THE ENGINE WILL NOT START AND THE DME IS NOT RESPONDING

F48 (X1)

With the B46O engine produced to 12/2015

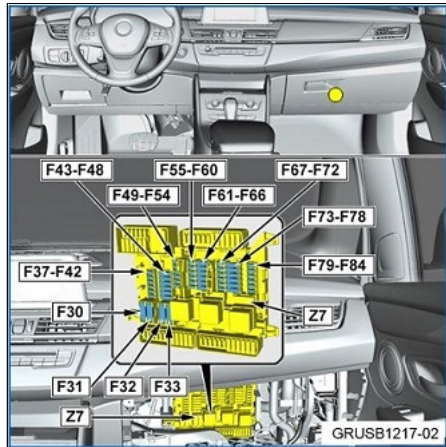
Fuse 83 (5A) is open.

When the turbocharger coolant pump is activated by the DME, the initial starting current could briefly exceed the 5A rating of Fuse 83 causing this fuse to blow.

If this occurs the engine will stop and cannot be restarted.

Replace F83's "5A" fuse with a "7.5A" fuse only

1. Install a replacement 7.5A fuse.
2. Make a change on the fuse reference card in the front power distribution box. for F83 from 5A to 7.5A
